GOVERNMENT OF THE DISTRICT OF COLUMBIA
DEPARTMENT OF TRANSPORTATION

MEMORANDUM

SUBJECT: **ZC 13-18** – Wheeler Renaissance, 4129-4131 Wheeler Road SE

Figure 1: Proposed Site Layout and Access. Source: Applicant's Supplemental Report 5/16/14. Gorove/Slade.

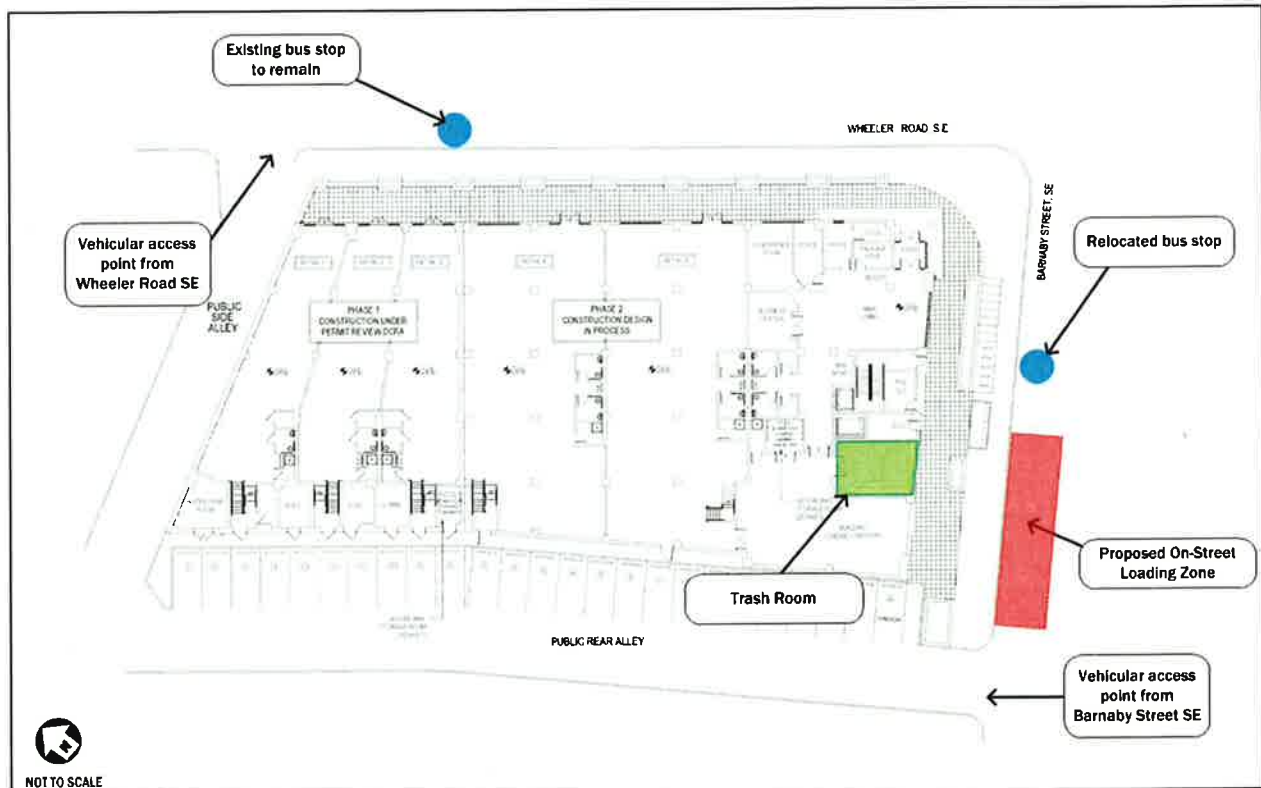
DDOT notes that curbside loading on Barnaby Street would not be located in close proximity to the retail establishments. Delivery drivers are likely to attempt to park their vehicles as close to the retail establishments as possible. The Applicant's analysis of truck turning diagrams revealed that trucks up to 28 feet in length are able to navigate the alley system adjacent to the site, which would allow deliveries to occur from the alley network. In addition, 30-foot trucks, which are not atypical for neighborhood serving retail deliveries, would be able to navigate the alley network with one backing maneuver. Accordingly, the alley network is sufficient to accommodate the anticipated loading needs.

The Applicant is proposing a Loading Management Plan to minimize the impact of loading activities. However, DDOT notes that the Loading Management Plan assumes that a curbside loading zone would be approved by DDOT, which is not a certainty. Therefore, the Loading Management Plan should include the following elements:

- Designate a loading management coordinator to coordinate all loading and trash activities for the building;
- Require all residential tenants to notify the loading coordinator before moving in or out;

- Limit delivery trucks to no greater than 30 feet in length. In the rare instance when larger truck deliveries are unavoidable, deliveries will be scheduled between the hours of 10am – 3pm and 8pm – 6am;

- Tenants requiring a moving truck must provide the loading coordinator the following information: time and date that the truck is anticipated to arrive, size of truck being used, and name of the moving service, if applicable; and

- In the absence of a curbside loading zone, the loading management coordinator or tenant will apply for DDOT Emergency No Parking signs to establish a temporary loading area, if necessary.

- All tenants and retailers will be provided with information regarding loading restrictions, rules, and suggested truck routes at lease signing.

Figure 4 Parking Inventory Map (Source: Applicant's CTR)

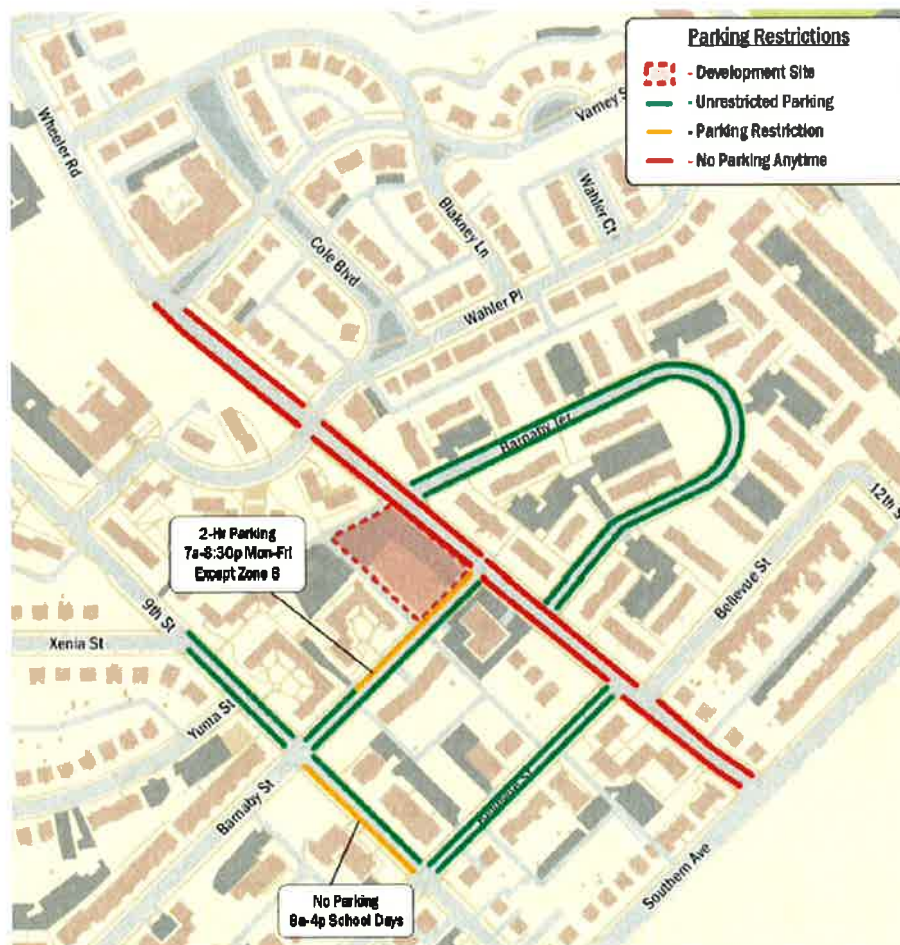
The Applicant conducted a curbside parking utilization study in an area surrounding the site to determine the availability of parking. The inventory noted a total of 174 curbside parking spaces in the vicinity; 6 RPP Zone 8 spaces, 14 school zone restricted spaces, and 154 unrestricted spaces. The RPP spaces are located adjacent to the site on Barnaby Street. The parking inventory is illustrated in *Figure 4*.
